Wadestown Shops cycleway audit – safety and accessibility

90% design audit

Paneke Pōneke
Bike network plan

July 2023

Figure 4: example of a raised platform width on the route.

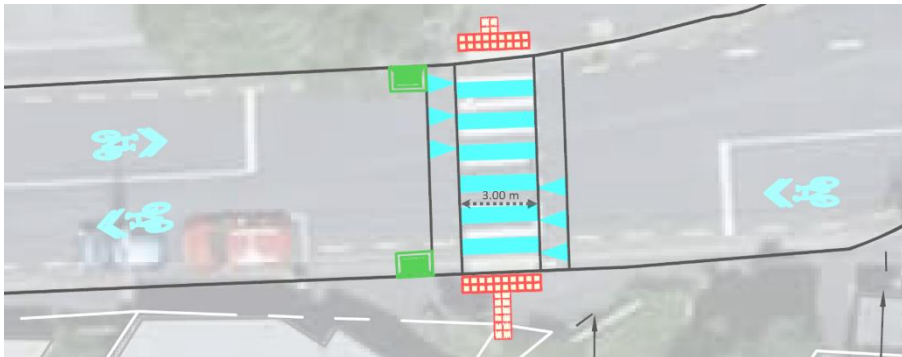
3.2 Raised crossings – M

To be an effective and safe system-compliant speed-calming device, a raised crossing should be at least 100 mm high, in which case it should also have a 6 m wide tabletop so that long vehicles (e.g., buses) always have at least one set of wheels on the crossing; otherwise, they may bottom out. This may result in unnecessary damage to the road, trucks, and public transport vehicles.

If the crossing platform is less than 100 mm high, the width requirement stated above is less important, but also unlikely to result in a meaningful reduction in traffic speed.

Probability of crash occurring	N/A
Expected crash severity	N/A
Primary treatment recommendations:	
3.2.1	N/A
Supporting treatment recommendations:	
3.2.2	Make platforms 6 m wide on bus routes.
3.2.3	Design crossings to be 75 mm high on bus routes and 100 mm in other areas (as discussed in Kilbirnie audit)

Designer	<p>We agree with CAT recommendation 3.2.2 and will update the designs accordingly. This also reflects feedback from the bus reviewers for the Berhampore to Newtown transitional cycleway.</p> <p>Both of these crossings are on a bus route so will be designed 75mm high in alignment with CAT recommendation 3.2.3</p>
-----------------	---

We note that in addition to the consideration for buses, a 75mm high platform is also designed to ensure that the stormwater secondary flow path continues along the road rather than spreading cross the footpath and into adjacent properties.
Safety Engineer	Agree with Designer’s response.
Proposed action	Agree with Designer’s response.
Client decision	Due to overhead constraints and footpath width constraints, the eastern most raised crossing is to be kept to 3.5 m wide.

Figure 5: Area without physical separations and only buffered edge line

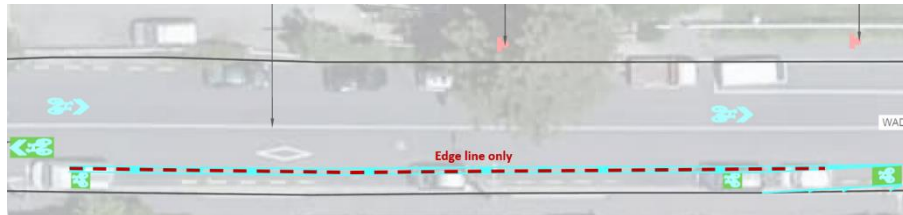
3.3 Lack of physical separation – **C E M**

The safety issue is the risk of drivers driving onto the cycle lane and hitting cyclists (Figure 5 and Figure 6). This risk is increased by the narrow width of traffic lanes and lack of centreline in some places.

The crash type expected are side swipe and rear end crashes between motor vehicles and riders. The risk factors include medium traffic volume exposure (4,000 to 6,000 vpd) and the operating speed of vehicles (35-39 km/h) which is above the tolerable impact speed for a crash between vehicles and cyclists/ electric scooter riders.

Probability of crash occurring	Unlikely
Expected crash severity	Serious injury
Primary treatment recommendations:	
3.3.1	Provide vertical separation along cycle lanes.
Supporting treatment recommendations:	
3.3.2	Provide buffered cycle lanes.
3.3.3	Designer to consider an advisory shoulder, also known as a 2-1 'two minus one' lane layout. This is a single lane with shoulders on either side for cyclists and e-scooter riders in urban areas. This would require considerable consultation with all road users to improve its acceptance and operation.

Responses:	
Designer	<p>Vertical separation and/or buffers were considered for this section but unable to fit between the kerb to kerb width for the full length considering other constraints and requirements (including retaining parking in the Wadestown Town centre as instructed by WCC).</p> <p>Whilst we accept the problem as described, we do not agree with CAT recommendation 3.3.3. With volumes up to 6,000 vehicles per day and a winding alignment that restricts forward visibility, we would assess that a 2 minus 1 alignment would increase the risk of drivers swerving into the shoulder area / cycle lane without checking for cyclists to avoid oncoming vehicles. We also note that where this option was proposed on the Ngaio transitional project it did not proceed due to technical advice from WCC and Waka Kotahi and public opposition.</p> <p>No change is proposed unless directed otherwise by the client decision</p>

Safety Engineer	Agree with Designer’s response. Also noting, 2 minus 1 configuration is not appropriate with the traffic volumes.
Client decision	Agree with designer and safety engineer.
Action taken	No change.

Figure 7: #134 – narrow lanes – no yellow centreline

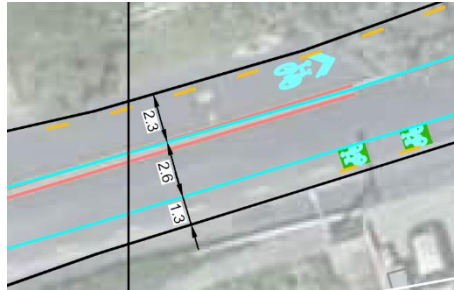
3.4 Traffic lane widths – C E M

The safety issue is larger cars, emergency vehicles and buses will not be able to pass each other (opposing direction) for some distance without encroaching on the cycle lane (which has vertical

Probability of crash occurring	Likely
Expected crash severity	Minor injury
Primary treatment recommendations:	
3.4.1	Where legal and absolute minimum lane widths cannot be achieved on a cross-section, provide traffic calming.
Supporting treatment recommendations:

separation) or the centre line. The presence of cyclists sharing the lane will be an added complexity adding to the situation.

3.4.2	Designer to provide the suitable lane widths. The absolute (legal) minimum traffic lane width is 2.5 m.
3.4.3	Designer to consider an advisory shoulder, also known as a 2-1 'two minus one' lane layout. This is a single lane with shoulders on either side for cyclists and e-scooter riders in urban areas.

Responses:	
Designer	<p>Vertical separation is only provided where the traffic and cycle lanes exceed minimum widths (1.5m cycle lane, 0.4m bollards, 2.9m traffic lanes in each direction).</p> <p>Refer to the response to Finding 3.3 above regarding the 2-1 'two minus one' lane layout response.</p> <p>We will further review the design and reallocate space to achieve a minimum 2.5m lane width in each direction.</p>
Safety Engineer	Agree with Designer’s response.
Client decision	Agree with designer and safety engineer.
Action taken	Not to implement two minus one. But to achieve minimum 2.5m traffic lane width.

Figure 8: #107 example of wide mixed lane.

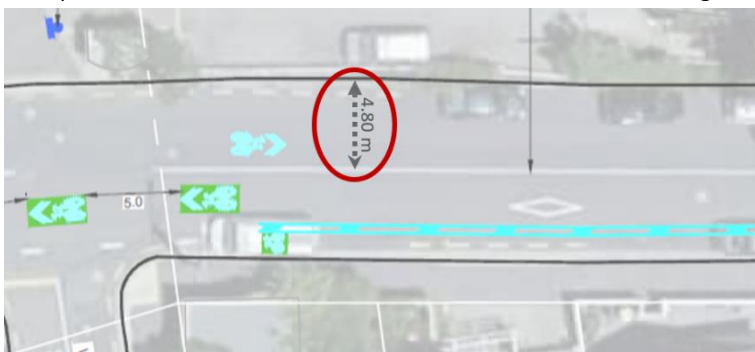
3.5 Lane widths for mixed traffic – C E M

The safety issue is lane widths for a mixed traffic lane, that change with kerbside parking, an example is shown in Figure 8. When cars are parked along here, this width could result in motorists overtaking cyclists where there is not sufficient space. This width also creates a situation where a rider may feel pressured to ride close to the kerb which further accommodates being overtaken.

There are several locations along the route where mixed traffic lanes are provided that fall in the “in-between” width range (3.3 m – 4.1 m) that should be avoided. There are some locations (mostly for the city-bound lane) where the lane widths are not shown plus other locations where the width from kerb to centreline is shown but this covers parking plus the live traffic lane; each of these situations could also fall in the in-between width range.

Probability of crash occurring		Unlikely
Expected crash severity		Serious injury
Primary treatment recommendations:		
3.5.1	N/A	
Supporting treatment recommendations:		
3.5.2	That all car parking spaces are marked to narrow the mixed traffic lane.	
3.5.3	Ensure mixed traffic widths are less than 3.2 m or more than 4.2 m to avoid drivers overtaking riders.	
3.5.4	Remove parking spaces where there is insufficient space.	
3.5.5	Mark parking lanes / spaces only where parking is permissible.

Designer	We agree with the CAT recommendations 3.5.2, 3.5.4 and 3.5.5 and will mark the parking spaces accordingly We also agree with CAT recommendation 3.5.3 and will review the lane width as part of the next design iteration.
Safety Engineer	Agree with CAT and Designer’s response.
Client decision	Agree with all four recommendations.
Action taken	Amend designs to marking parking and traffic lanes as advised.

Figure 11: example where no ASBs are provided

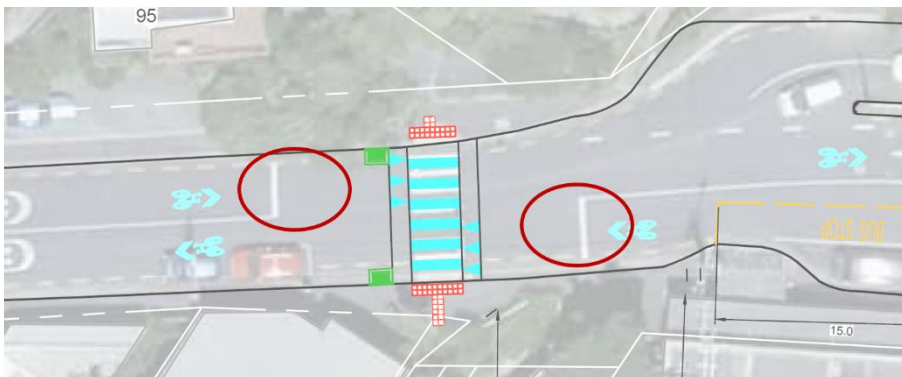
3.7 Advanced stop boxes – **C E**

There is no facility for cyclists to wait ahead of traffic at the zebra crossing at Fancourt Street. This creates a potential safety issue where drivers may not be aware of riders alongside as they move off across the zebra crossing.

Probability of crash occurring	N/A
Expected crash severity	N/A
Primary treatment recommendations:	
3.7.1	N/A
Supporting treatment recommendations:	
3.7.2	Provide Advanced Stop Boxes at limit lines for cyclists in mixed traffic lanes. Note that this issue recurs throughout the design.

Designer	This Waka Kotahi guidance relates to signalised intersections rather than zebra crossings. The intersection waiting time is typically higher and more frequent at signalised intersections providing incentive and time for cyclists to move to the front of the queue, whereas waiting at a pedestrian crossing is typically more momentary (at 1.5m/s it will take a pedestrian
-----------------	---

approximately 8 seconds to cross the 10m crossing). We consider it safer for cyclists to stay within the shared traffic lane rather than trying to advance between vehicles and the kerb to the front of the queue and this is expected to have limited impact on cyclists convenience.
Safety Engineer	Agree with Designer’s response. Consistency of markings throughout the network is of key importance.
Client decision	Agree. Do not mark ASBs at pedestrian crossings.
Action taken	No change.

Figure 12: Examples of poor sharrows placement.

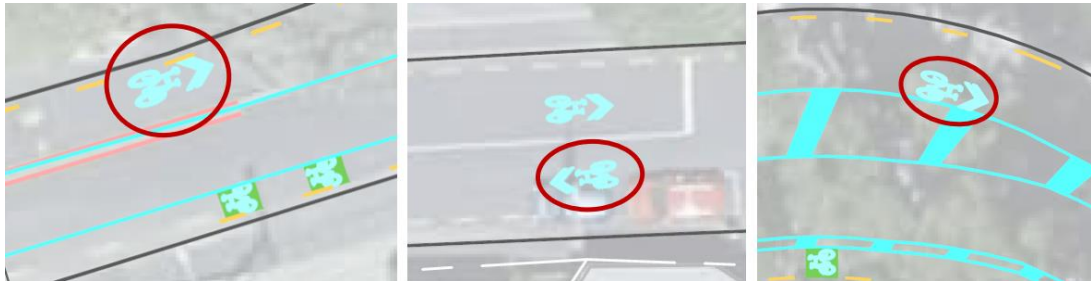
3.8 Sharrows placement – C E M

The issue is cyclists not taking the lane correctly locating themselves in the lane as indicated by the sharrows placement.

Probability of crash occurring	N/A
Expected crash severity	N/A
Primary treatment recommendations:	
3.8.1	N/A.
Supporting treatment recommendations:	
3.8.2	Ensure sharrows are placed correctly to encourage cyclists to take the centre of the lane.

Designer	We agree with the CAT recommendation, and the sharrows locations will be updated prior to the next drawing issue
Safety Engineer	Agree with CAT and Designer’s response.
Client decision	Agree with everyone.
Action taken	Sharrows to be updated in next drawing set.

Figure 13: #142-158 example of cycle Lane on inside of curve

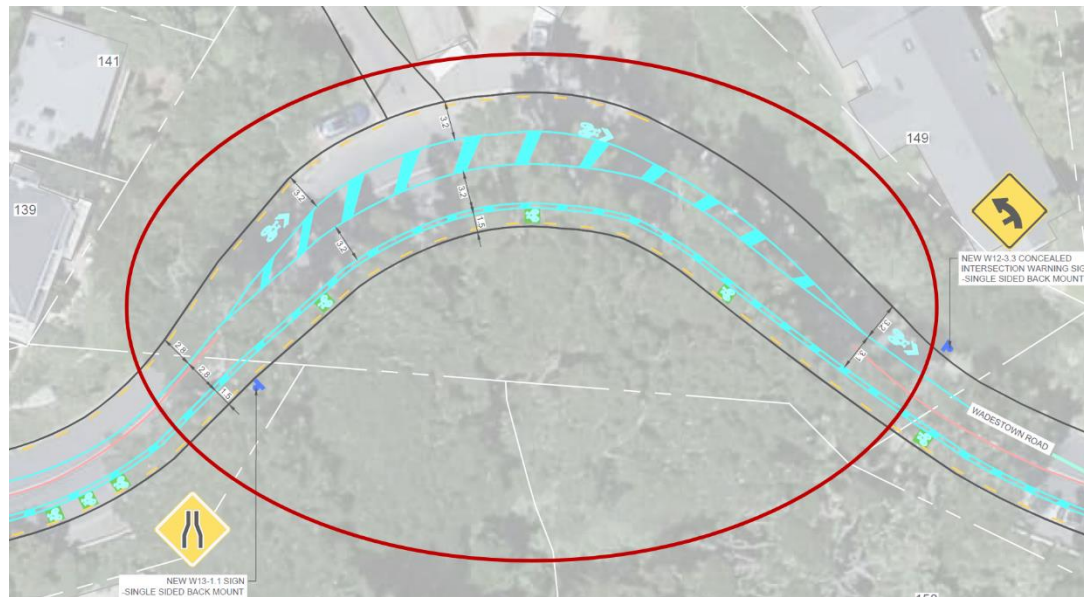
3.9 Cycle lanes on inside of curves – **C E**

The safety issue is several sections along Wadestown Road where there is a cycle lane without separators is located on the inside of a curve, see Figure 13. In such locations, motorists are more likely to track into the cycle lane while cornering and could hit a cyclist.

Probability of crash occurring	Unlikely
Expected crash severity	Serious injury
Primary treatment recommendations:	
3.9.1	Provide vertical separation within the buffer on the inside of curves.
Supporting treatment recommendations:	
3.9.2	N/A

Responses:	
Designer	We agree with the CAT recommendation, and this will be reviewed, and the design updated subject to vehicle tracking requirements prior to the next drawing issue
Safety Engineer	Agree with CAT and Designer’s response.
Client decision	Agree with all of the above.
Action taken	Review and add separators on the corner, subject to bus tracking.

Figure 16: sharrows on uphill gradients near shops

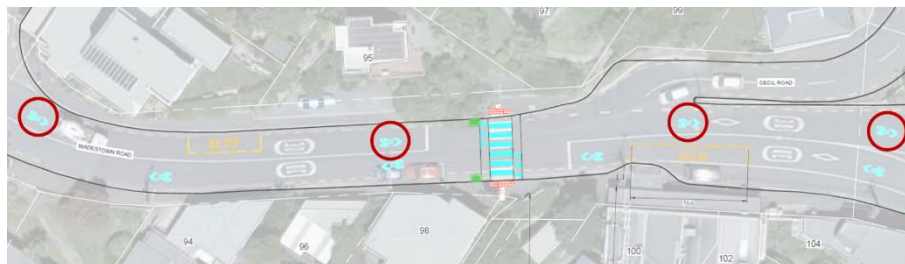
3.13 Sharrows on an uphill gradient – C E M

The safety issue is the higher speed differential between riders and vehicles on an uphill gradient where riders are encouraged to ‘take the lane’.

3.13.1 Provide separation for cyclists on uphill gradients.

3.13.2 That motorist and rider speeds are measured along the route where sharrows are provided on uphill grades to determine if more traffic calming is required.

Designer	<p>We note that the sharrows circled are in the downhill direction but acknowledge that the finding equally applies for the sharrows on the other side of the road in Figure 19.</p> <p>We agree with the CAT finding. Separation through Wadestown Village was considered at concept design. That option received the highest score from the MCA assessment of options. However, WCC chose to progress design for Option 2 (sharrows) as it retained high value parking. This shared lane approach is consistent with the treatment through village shopping areas on other transitional projects (e.g. Aro Valley).</p> <p>Direction is required by the client decision</p>
Safety Engineer	Agree with CAT. Traffic and cyclist speeds should be monitored. If the speed differential is excessive, additional traffic calming measures should be considered.
Client decision	Monitor speed differential after installation and add traffic calming if required. Note that WCC speed management programme may result in a speed reduction on Wadestown Road around the same time this section of Wadestown Connections is installed.

Action taken	Add speed monitoring to post installation report.

Figure 18: possible direction of vehicles following the new line markings.

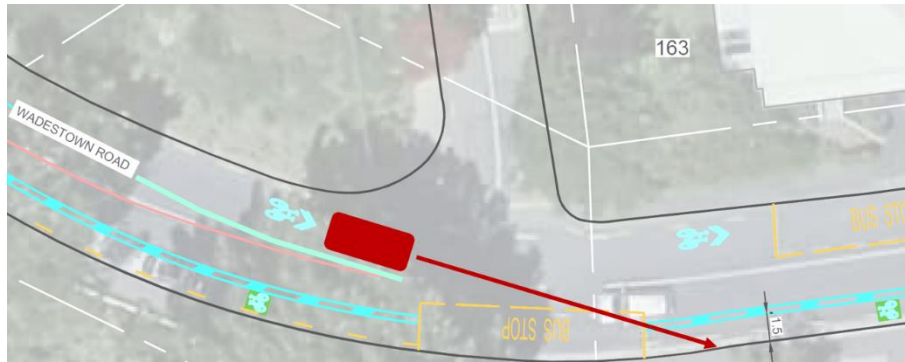
3.14 Line marking alignment – C E M

The safety issue is road users traveling along Wadestown Road being guided towards the opposing lane by new line markings (Figure 18 shows where a driver could end up if they followed the centre line markings).

Probability of crash occurring	Unlikely
Expected crash severity	Minor injury
Primary treatment recommendations:	
3.14.1	N/A
Supporting treatment recommendations:	
3.14.2	Ensure the new centreline road markings direct traffic around the curve in the correct direction.

Responses:	
Designer	We agree with the CAT recommendation, and this will be implemented as part of the next drawing issue
Safety Engineer	Agree with CAT and Designer’s response.
Client decision	Agree with the above.
Action taken	Centreline to be adjusted in the next set of drawings.

Figure 19: Lane width past in lane bus stop

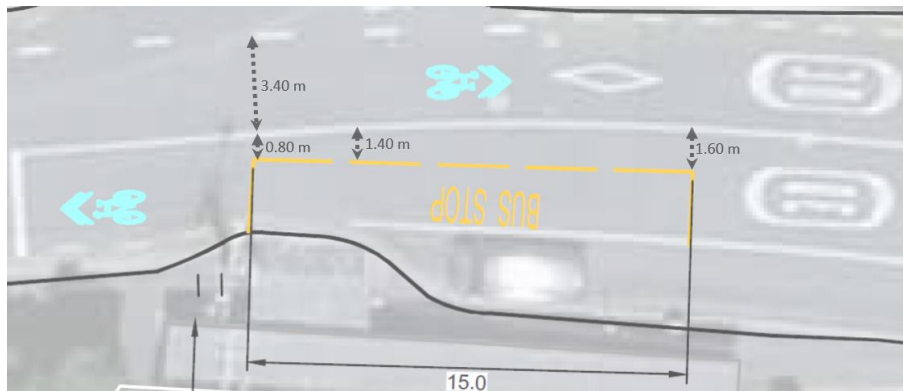
3.15 Narrowing lane past bus stop – C E M

The safety issue is the unexpected lack of space between the bus stop and centreline for riders. Also see issues 3.10 and 3.11.

Probability of crash occurring	Unlikely
Expected crash severity	Non-injury
Primary treatment recommendations:	
3.15.1	N/A
Supporting treatment recommendations:	
3.15.2	See 3.11.2 and 3.11.3.
3.15.3	Ensure the eventual narrow width is clear to uphill riders when a bus is present.

Responses:	
Designer	We agree with the CAT recommendation, and this will be reviewed prior to the next drawing issue to provide a consistent width between the bus stop and centre line
Safety Engineer	Agree with CAT and Designer’s response.
Client decision	Agree with the above.
Action taken	Centreline to be adjusted in the next set of drawings.
